Access Compliance Report

Public Rights-of-Way

(Curb Ramps)

Intersection ID: 10018365	Main Street: BANYAN_CT	Cross Street: N/A	Location: W
ADA ID: FE0807079A31	Ramp Type: Perp	Initial Pass/Fail: Fail	Overall Compliance: No
Severity Score: 12.5			
Codes/Mitigation Info/Possible Solution		Field Measurements/Component Compliance

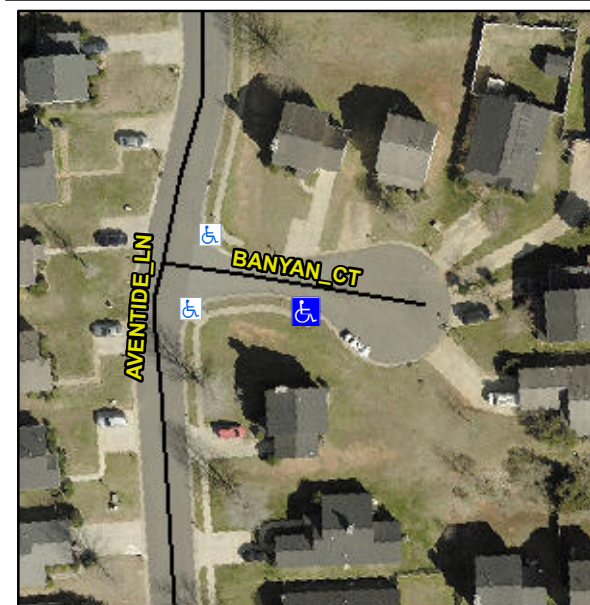
Not Found, R304.5.3

Compliance	Description	Data	Compliance	Description	Data
N/A	Ramp Length (in)	47.0	Yes	Ramp Slope (%)	7.5
Yes	Ramp Width (in)	48.0	No	Ramp XSlope (%)	5.4
N/A	Flare Type LT	N/A	N/A	Flare Type RT	N/A
N/A	Flare Slope LT (%)	N/A	N/A	Flare Slope RT (%)	N/A
N/A	Flare Traversable LT?	N/A	N/A	Flare Traversable RT?	N/A
N/A	Landing Length (in)	N/A	N/A	DWS Provided?	N/A
N/A	Landing Width (in)	N/A	N/A	DWS Contrast?	N/A
N/A	Landing Slope (%)	N/A	N/A	DWS Length (in)	N/A
N/A	Landing X Slope (%)	N/A	N/A	DWS Full Width?	N/A
N/A	Landing Curb? (Y/N)	N/A	N/A	DWS Offset (in)	N/A
N/A	Shared Landing?	N/A			
N/A	Gutter Ponding?	N/A	N/A	Gutter Slope (%)	N/A
N/A	Gutter Lip Ht (in)	N/A	N/A	Gutter X Slope (%)	N/A
N/A	Painted X Walk1?	No	N/A	Painted X Walk2?	N/A
	X Walk 1 Direction	To N		X Walk 2 Direction	N/A
N/A	X Walk 1 Width (in)	N/A	N/A	X Walk 2 Width (in)	N/A
	X Walk 1 Slope (%)	1.8		X Walk 2 Slope (%)	N/A
	X Walk 1 X Slope (%)	6.4		X Walk 2 X Slope (%)	N/A

Remove & Replace Entire Ramp.
